**COMMENTS AND CONCERNS
REGARDING THE PROPOSED WATE MINE
AND POTENTIALS FOR EXPANDED ARIZONA STATE LAND
BRECCIA PIPE URANIUM MINING**

**Prepared by Grand Canyon National Park,
Division of Science and Resource Management**

May 9, 2013

DOCUMENT REVIEW COMMENT FORM-GRAND CANYON NATIONAL PARK

Figure 2. Wate Claim area map with general groundwater flow directions and known springs and seeps.

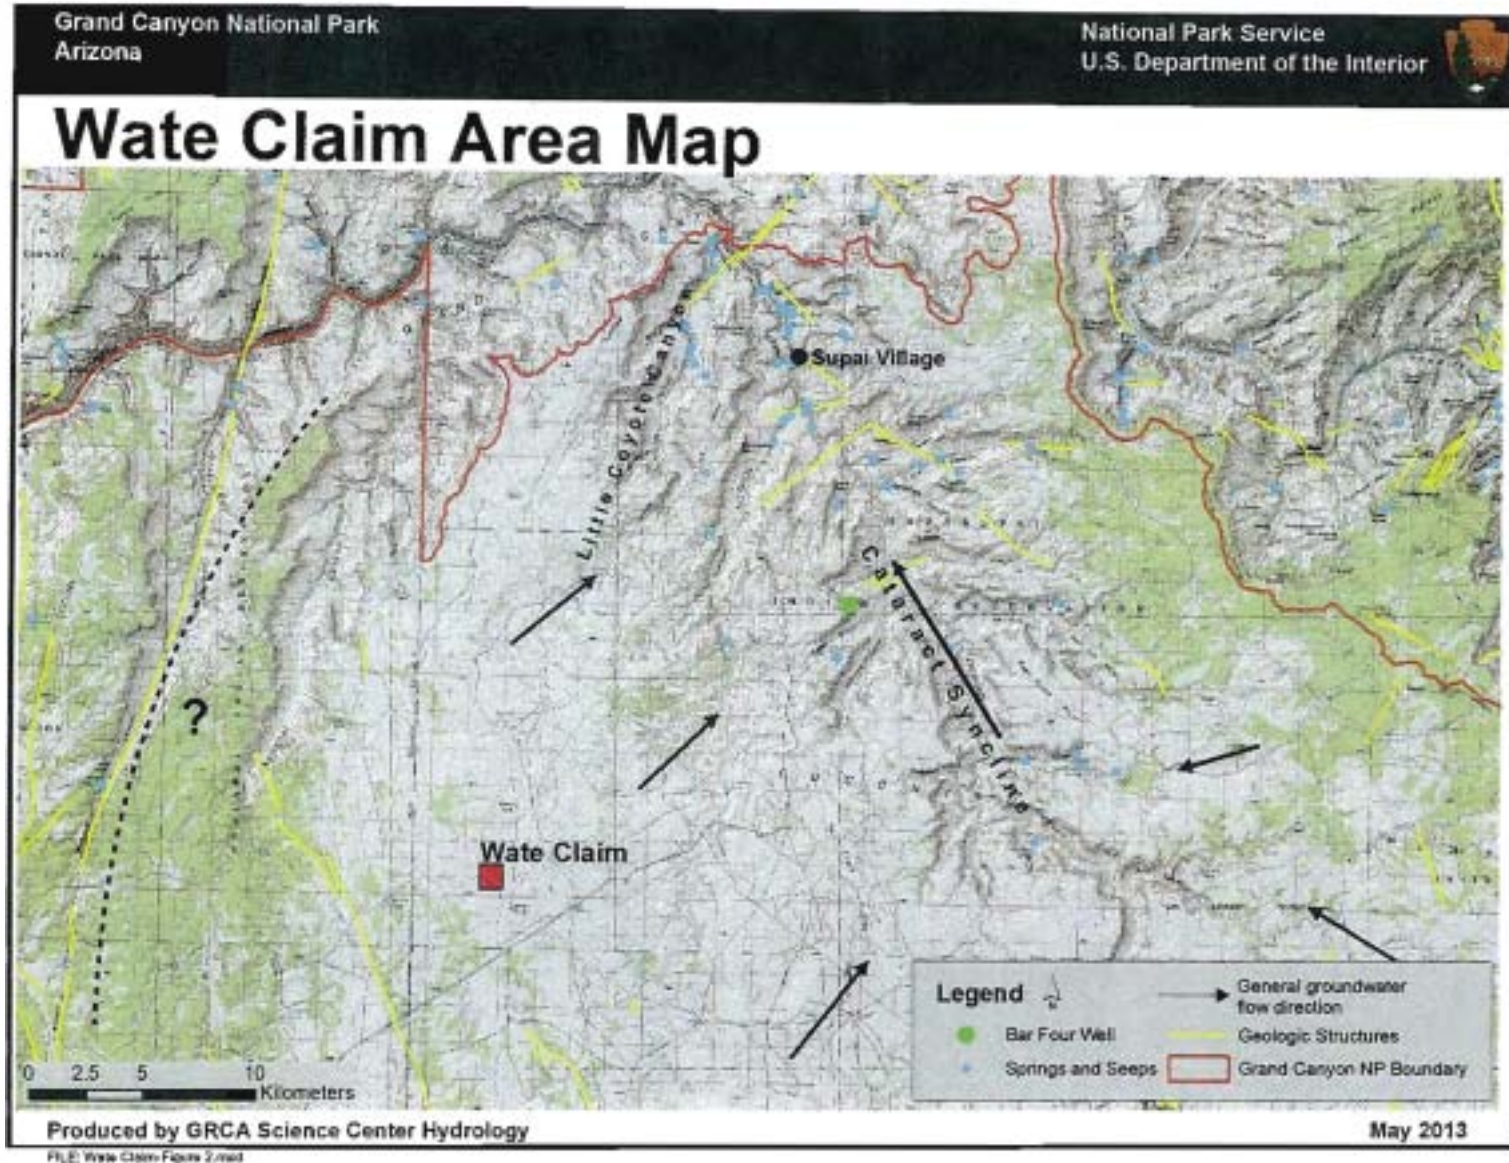
3.8.1	23 of 52	<p>Springs are located not only less than the 15 miles away stated by the applicant, but these springs also issue from shallow aquifer systems at higher elevations than claimed by the applicant (Figure 2).</p> <p>Within about 15 miles or less from the Wate parcel, there are 7 confirmed springs that discharge from aquifers above the regional Redwall-Muav aquifer (Coconino Sandstone, Esplanade Sandstone, or Supai Group), all above the 3,200ft upper limit claimed by the applicant. These springs discharge at a depth below the plateau surface of between 1,090 and 2,290ft, with 3 locations above the proposed depth of the mine shaft (1,700ft).</p> <p>It is evident that shallow groundwater does exist in the area. However, the extent, depth, and behavior are unknown. Creating artificial drains to these aquifers by drilling mine shafts and excavating material for ore extraction could potentially affect the locations where this groundwater discharges at the surface, although the timescales and magnitudes of impact are unknown.</p>

Figure 3. State Land uranium targets showing proximity to mineral closures, springs, seeps, and wells.

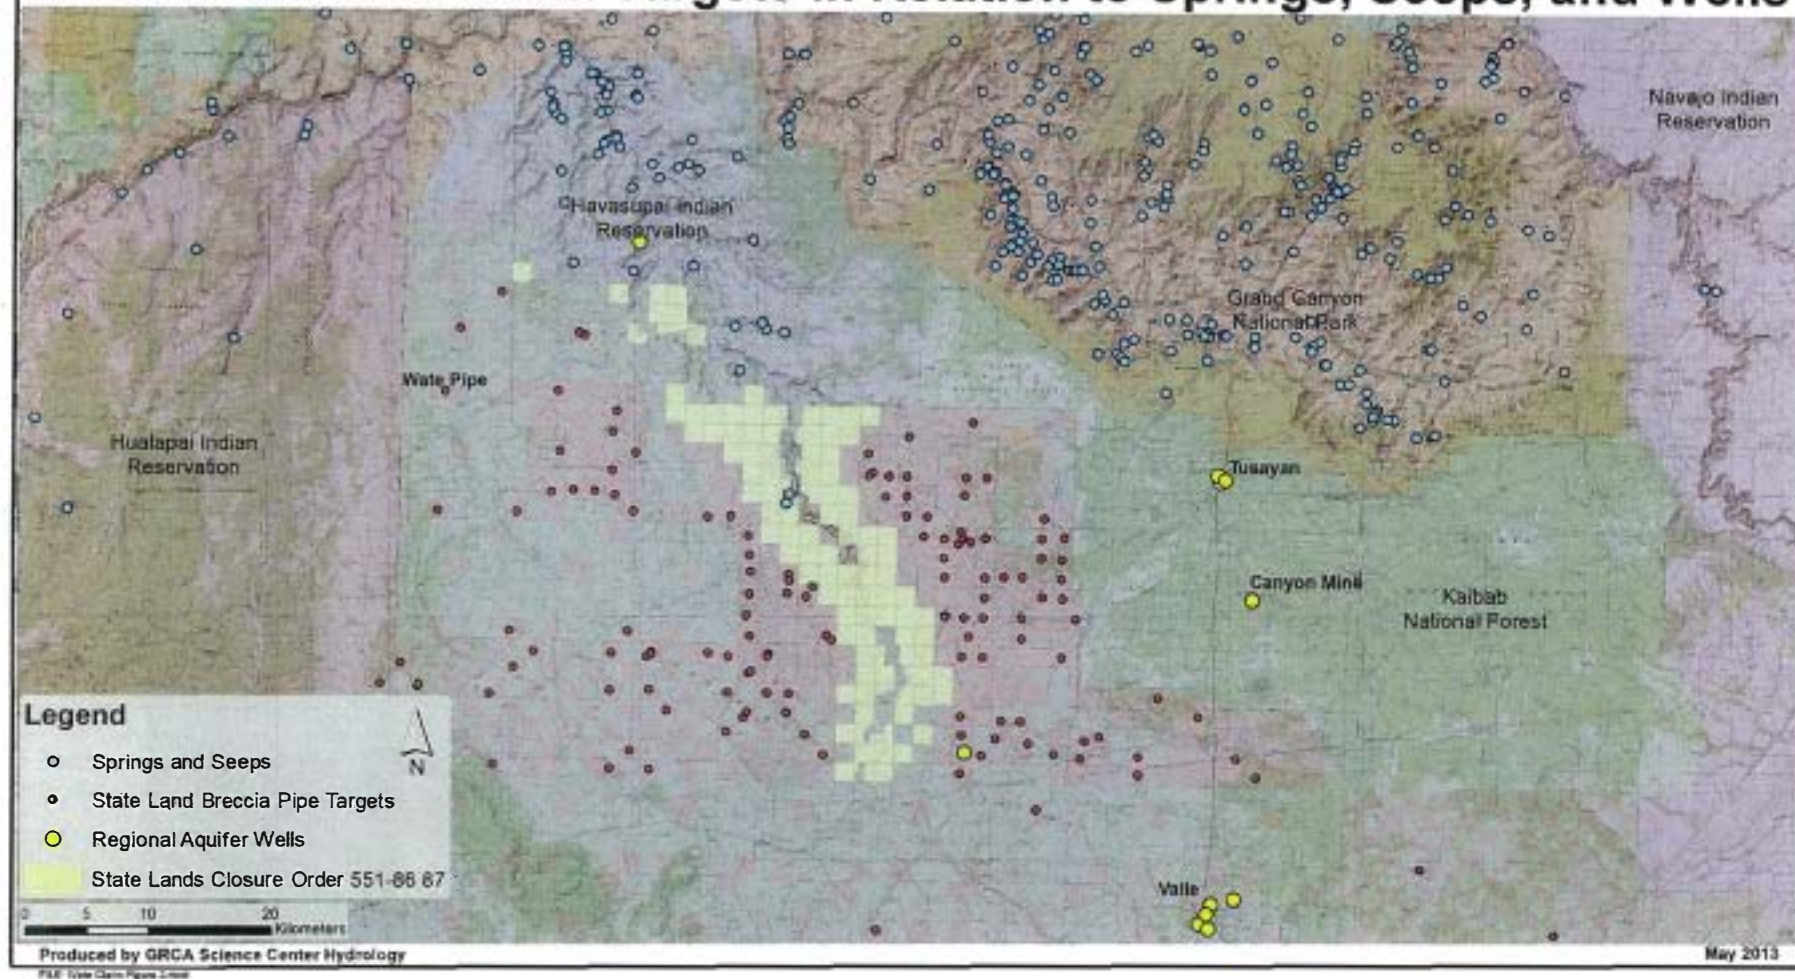
The Arizona State Land Department has already closed a number of sections of land to mineral entry to protect a portion of Cataract/Havasupai Canyon (Closure Order 551-86/87, appended by 251-2010/2011) (**Figure 3**). While admirable, this order only partially protects a section of the surface watershed of Cataract Canyon. The remainder of the surface watershed and the groundwater basin supporting Havasu Creek extends well beyond this closure area and warrants similar protections. Rather than setting a precedent for expanded uranium mining on the Coconino Plateau by approving the Wate Mine, the State Land Department has the opportunity to set a precedent by expanding current mineral closures to protect the Grand Canyon watershed from potential impacts resulting from breccia pipe uranium mining. Such an action would be in line with the State Land Department agency goal to “incorporate environmental protection into the Department’s management actions to enhance the future productivity of the Trust’s land and assets.” (AZSLD, 2013).
